SA-22-3

Safety Advisory

Subject: Steering Gearbox Bolt Failure

Figure 1 – Bolts that secure the steering gearbox mounting plate assembly to the vehicle frame are circled in red. (Image Source: Nova Bus)

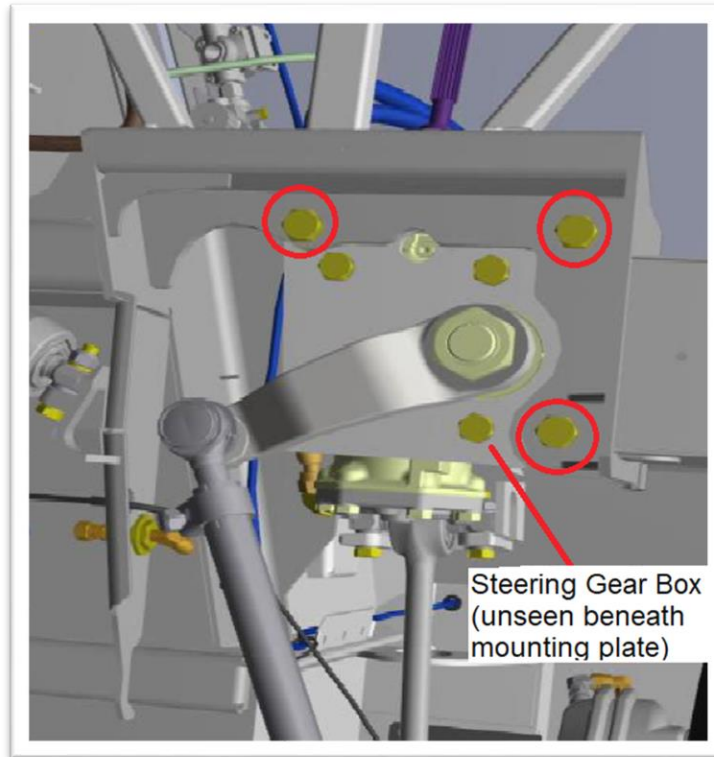
FTA has become aware of a steering gearbox mounting plate bolt failure on some new buses manufactured by Nova Bus that are equipped with Bosch steering gearboxes. Bolts that secure the power steering gearbox mounting plate assembly to the vehicle frame may come loose and, in some cases, fall out.

Nova Bus confirmed that the affected buses are equipped with a smaller Bosch steering gearbox that requires an additional mounting plate to secure it to the subframe. Please see *Figure 1*.

FTA’s preliminary assessment suggests that, if the power steering gearbox is not secured to the mounting plate or the mounting is not secured to the vehicle frame, an operator may not be able to control the steering of the bus.

An issue was recently found on some Nova Bus vehicles equipped with a Bosch steering gearbox. The issue concerns the 7/8" bolts (3) that secure the steering gearbox mounting plate assembly to the vehicle frame.

- Visual inspection to confirm the presence of the three (3) bolts;
- Visual inspection to confirm the torque seal marks are not broken on these bolts;
- Torque inspection and retorque of these bolts to the nominal value of 452 N.m.
- Apply new torque seal marks to the bolts.
